FISH AND WILDLIFE SERVICE Mountain-Prairie Region

Attachment
Additional Information in Response to the Second Stakeholder Proposal in Connection with USFWS
Impairment Complaint at the Quivira National Wildlife Refuge
March 22, 2017

Figure 1: Map from Kansas Geological Survey Open File Report 94-28c showing the amount of freshwater available near the Refuge.

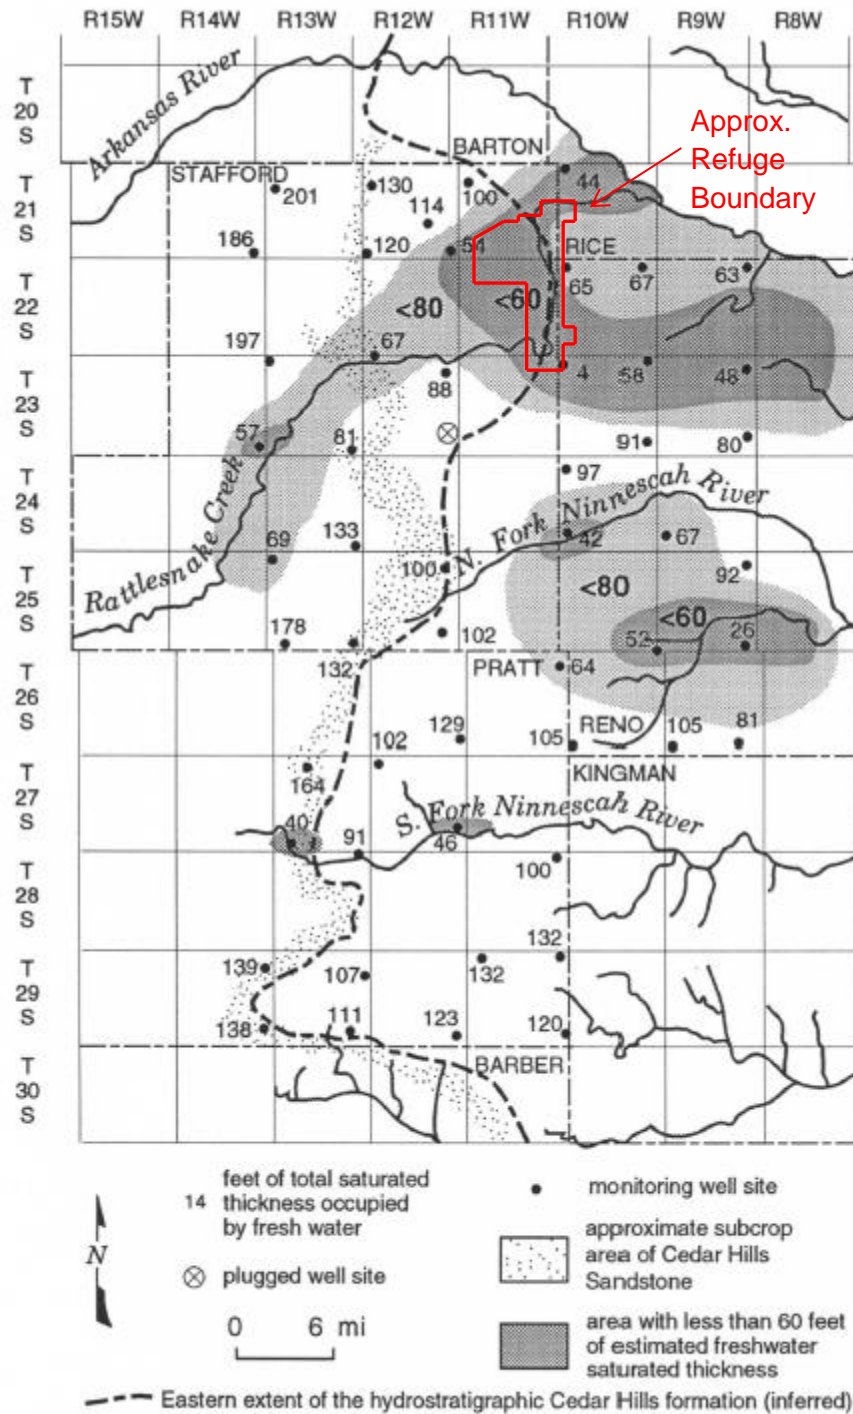
The proposal indicates that both Option 1 and Option 2 would involve siting augmentation wells near the east or west boundary of the Refuge, respectively. The aquifer underneath and adjacent to the Refuge has been documented as saline (Kansas Geological Survey (KGS) Publication 94-28 c and 92-44) and, based on the general locations of wells proposed in both options, less than 60 feet of freshwater is available for pumping (see Figure 1 below). Although Option 2 offers assurances that there are confining layers present that will prevent upconing of salt water, past monitoring conducted approximately 8 miles northwest of the Refuge (Siefkes site; KGS Publication 94-28c) indicated that the potentiometric surface of deep brackish to saline water exceeds that of the upper freshwater aquifer with minimal pumping and led to poor water quality being produced. Based on monitoring data at this site, KGS Publication 2000-60 (2001) states “These observations indicate that even in places where a clay lens occurs, separation between the freshwater aquifer and the deep aquifer is not complete, and measures need to be taken to avoid dangerous increases of salinity in the fresh groundwater resource.” Further, the site monitored has more freshwater available than areas closer to the Refuge and is indicative of the salinization risk to the upper aquifer that is posed by wells located within the mineral intrusion zone.

Based on this information, the opinion of the Service is that augmentation wells sited in the general locations identified in both Option 1 and Option 2 have a high chance of producing poor quality water that would not satisfy K.S.A 82a-706b (a)(2). If this were to occur, the potential exists to introduce lower quality water than what is present in Rattlesnake Creek, which may violate state water quality requirements for wetlands with Tier 3 protections. Additionally, continued upconing of salt water may result in irreversible salinization of the aquifer and would jeopardize the ability of augmentation to meet its intended purpose. Salt water intrusion would also unacceptably impact Refuge resources. Therefore, the Service cannot accept either Option 1 or Option 2 as proposed.

Figure 2: Map from Rattlesnake Creek Management Program Proposal (KDWR, 2000) showing the location of the mineral intrusion area.

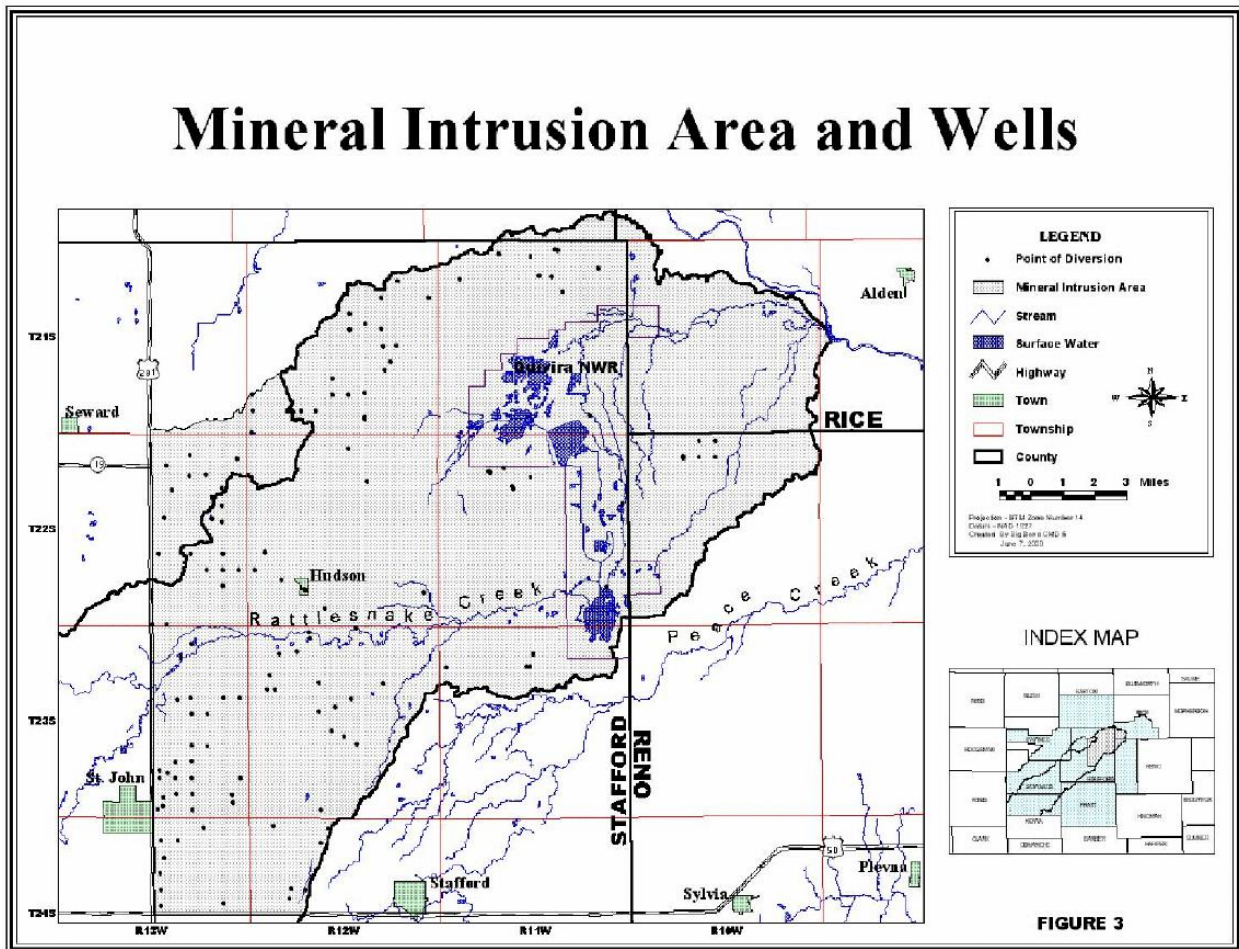
2. If GMD #5 remains committed to a remedy that includes augmentation, the Service:
 - a. Considers augmentation wells outside the mineral intrusion zone (Figure 2) as the only suitable location to minimize the risk of providing water of insufficient quality during droughts, when the greatest demand is placed on the aquifer. This view is supported by the Kansas Water Office report (2006) that stated "Should the augmentation strategy be implemented, the Kansas Water Office recommends the use of freshwater sources for augmentation..."
 - b. Will require any proposal that includes augmentation near the refuge to be confirmed by research conducted by qualified personnel that (i) ensures well locations and operations

- ii. There is a large risk of introducing invasive species with any large scale construction project.
 - iii. Causing upconing of saline water from the deep aquifer and introducing it into the Refuges is an unacceptable risk the Refuge does not support. The Service will not promote intense groundwater pumping within the mineral intrusion zone.
